# SUBDIVISION REPORT - CONCEPT/DEVELOPMENT PLAN

► FILE #: 11-SC-25-C AGENDA ITEM #: 30

11-H-25-DP AGENDA DATE: 11/13/2025

► SUBDIVISION: THOMPSON CREEK

ROAD A PROFILE

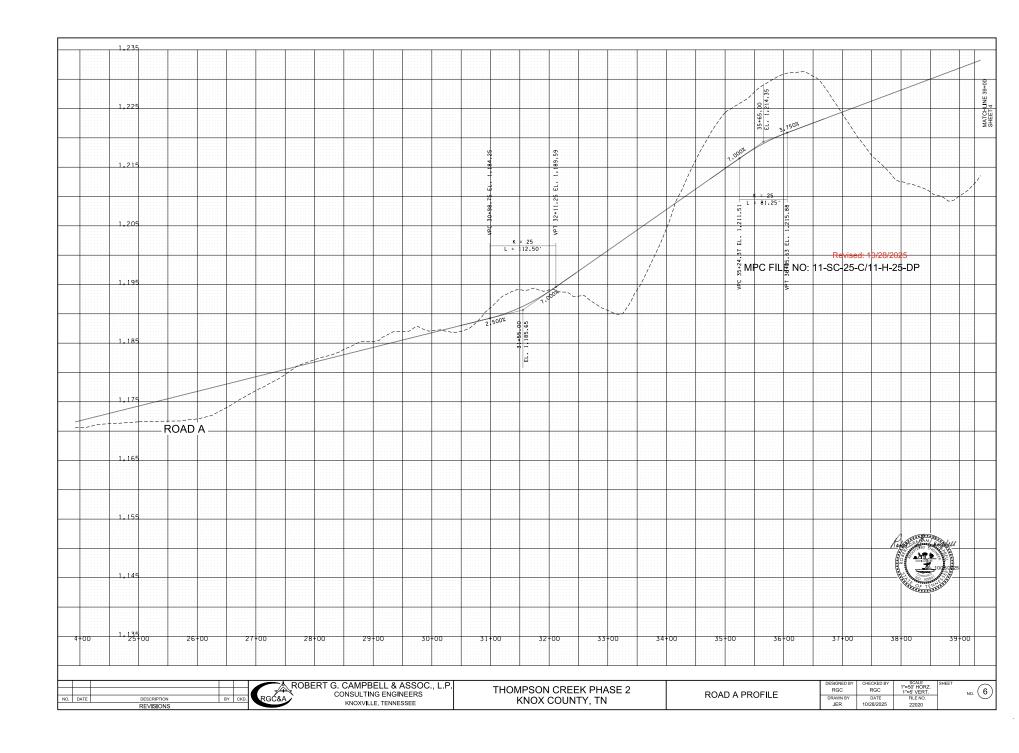
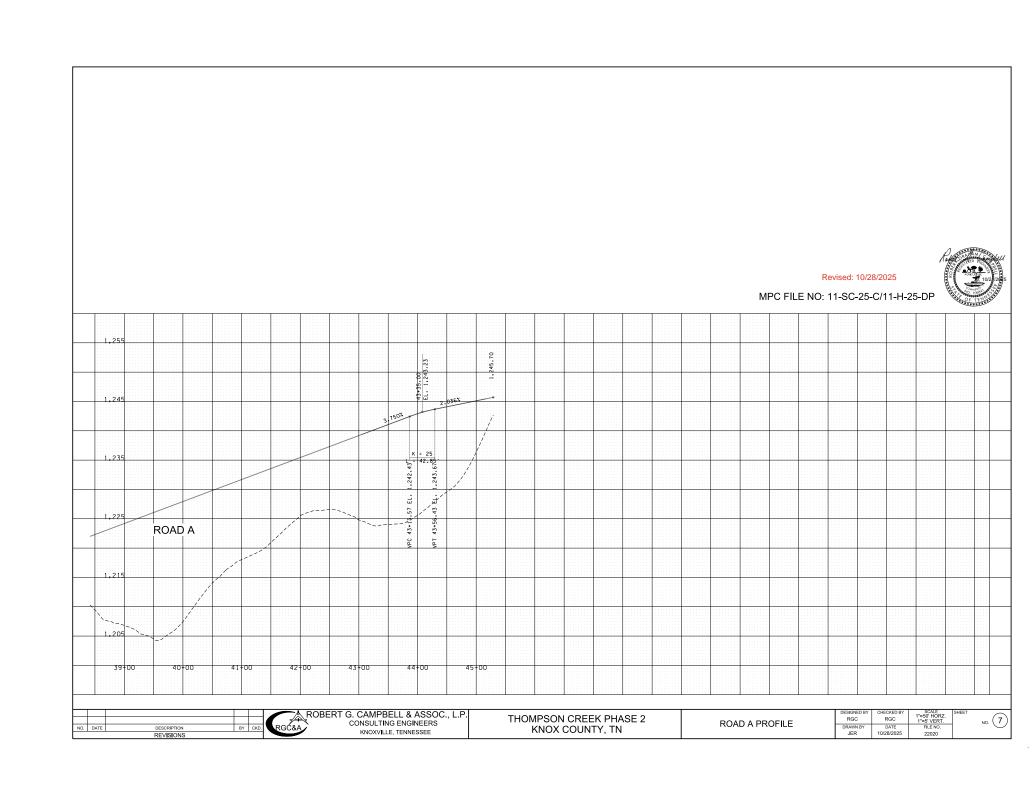
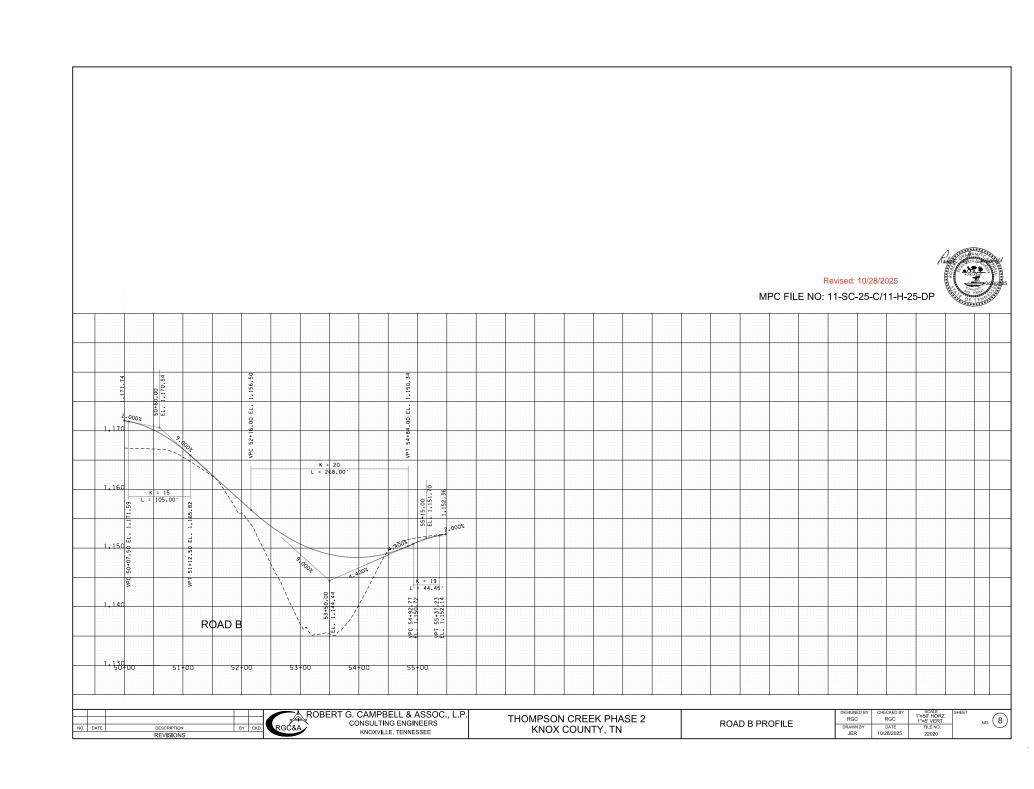
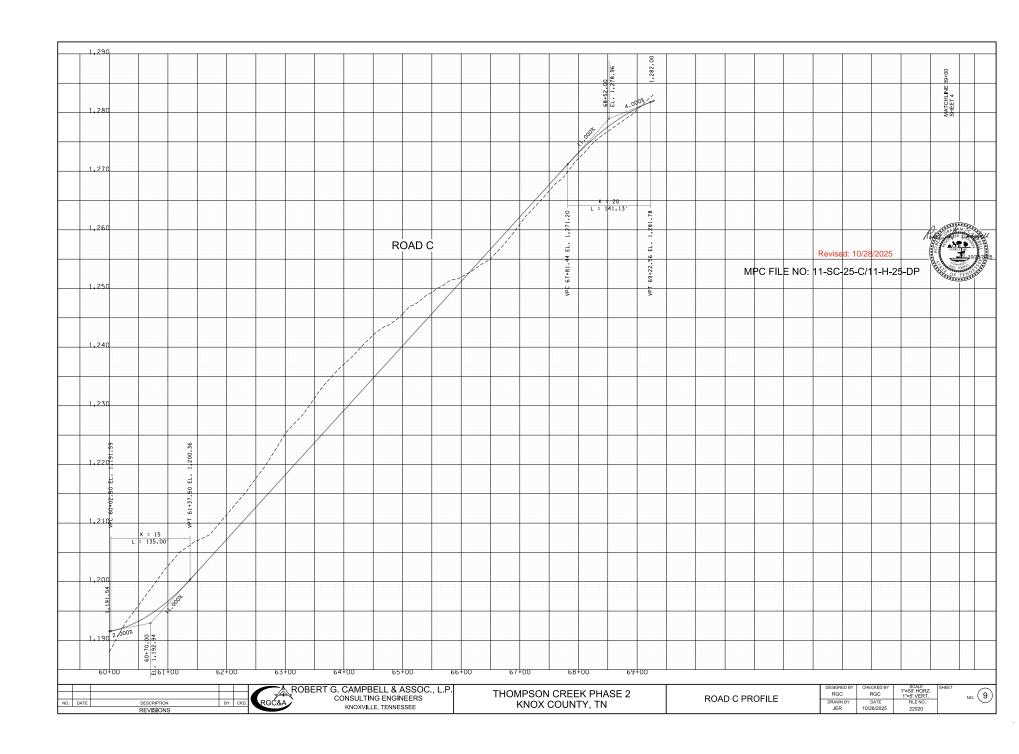
1. Reduce the minimum broken back curve tangent length on Road 'B'

2. Reduce the minimum vertical curve K-value on Road 'B' from 25 to

3. Reduce the minimum vertical curve K-value on Road 'B' from 25 to

5. Reduce the minimum vertical curve K-value on Road 'A' at the

- ► Approve the variance to reduce the minimum broken back curve tangent length on Road 'B' from 150 ft to 71.79 ft between curve C23 and C24, based on the following evidence of hardship.
  - A) The reduced tangent between horizontal curves allows for less disturbance into the floodplain to the south and HP (Hillside Protection) area to the north.
  - B) The stream and steep slopes are preexisting conditions on the site.
  - C) Approval of the variance is not anticipated to be detrimental to public safety, health, or welfare because the short street length is anticipated to result in lower vehicle speeds. The Knox County Department of Engineering and Public Works recommends approval of this variance based on the justification provided by the applicant.

Approve the variance to Reduce the minimum vertical curve K-value on Road 'B' from 25 to 20 at STA 53+50.00, based on the following evidence of hardship.

Approve the variance to reduce the minimum vertical curve K-value on Road 'B' from 25 to 19 at STA 55+15.00, based on the following evidence of hardship.

Approve the variance to reduce the minimum vertical curve K-value on Road 'A' at the intersection approach with Thompson School Road from 25 to 15, based on the following evidence of hardship. A) The reduced K-value allows for less grading and positive stormwater drainage away from

- A) The reduced K-value allows for less disturbance into the floodplain to the south and HP (Hillside Protection) area to the north.
- B) The stream and steep slopes are preexisting conditions on the site.
- C) Approval of the variance is not anticipated to be detrimental to public safety, health, or welfare because the request meets the American Association of State Highway and Transportation Officials (AASHTO) design standards. The Knox County Department of Engineering and Public Works recommends approval of this variance based on the justification provided by the applicant.

- A) The reduced K-value allows for less disturbance into the floodplain to the south and HP (Hillside Protection) area to the north.
- B) The stream and steep slopes are preexisting conditions on the site.
- C) Approval of the variance is not anticipated to be detrimental to public safety, health, or welfare because the request meets the American Association of State Highway and Transportation Officials (AASHTO) design standards. The Knox County Department of Engineering and Public Works recommends approval of this variance based on the justification provided by the applicant.

- B) The slopes along the Thompson School Road frontage are a preexisting condition on the site.
- C) Approval of the variance is not anticipated to be detrimental to public safety, health, or welfare because the request meets the American Association of State Highway and Transportation Officials (AASHTO) design standards. The Knox County Department of Engineering and Public Works recommends approval of this variance based on the justification provided by the applicant.
